Rezoning Transportation Analysis

Petition Number: 2019-124

Reviewer: Molly T Haynes, PE
mhaynes@charlottenc.gov
704-336-1496

Date	Description
09-27-19	First Review
11-12-19	Second Review

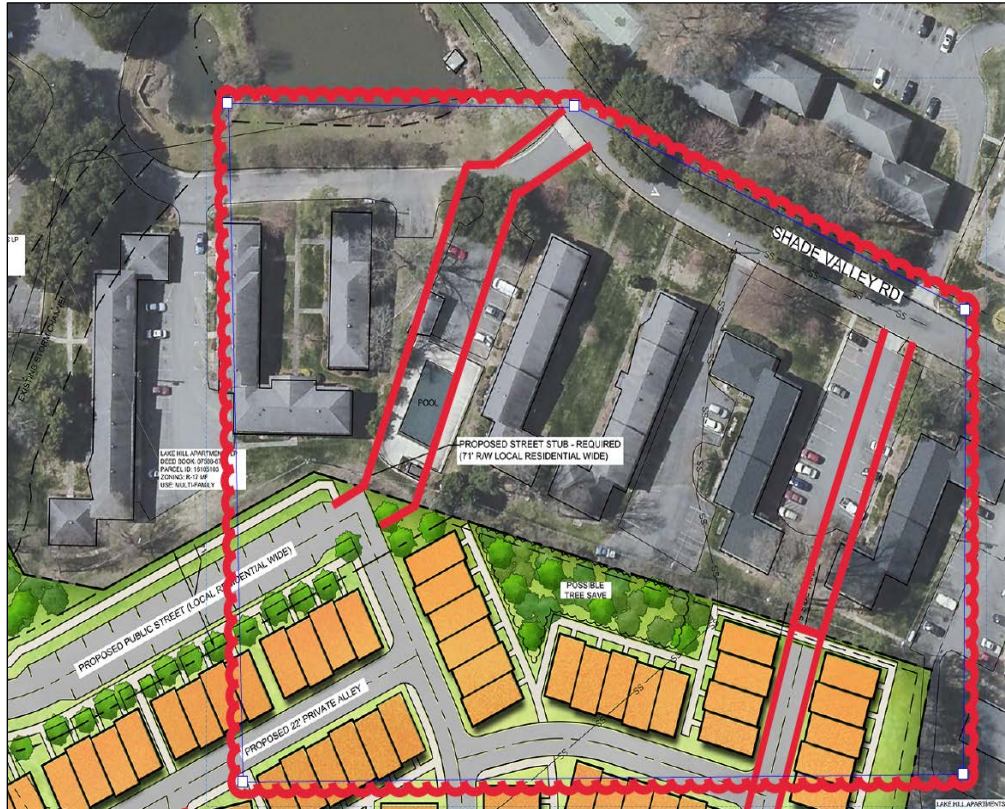
- ~~The petitioner should revise the site plan and conditional note(s) to update the existing streetscape to comply with the Chapter 19 Ordinance. The petitioner is required to construct 8-foot planting strip, and 8-foot sidewalk along Monroe Road (Parcel ID 161-05-113 and 161-05-114). The Independence Boulevard Area Plan typical plan is shown below.~~

5. CDOT is requesting the petitioner revise the site plan and conditional note(s) to commit to construct a 10-foot shared use path, at the back of curb, on Monroe Road property frontage (Parcel ID 161-05-113 and 161-05-114) to meet the City's Monroe Road Streetscape Project. The site plan should label and dimension both items from the back of curb and gutter and road centerline.
6. ~~The petitioner should revise the site plan to provide USDG typical sections for all private streets.~~
 - a. ~~In addition, provide a public access easement on the following private streets shown in the illustration below (shown in red) to accommodate future street connectivity.~~

- b. ~~The petitioner should reconfigure the internal street network to provide future street connectivity between Shade Valley Road and Eaton Road. See CDOT suggestions illustrated in red.~~
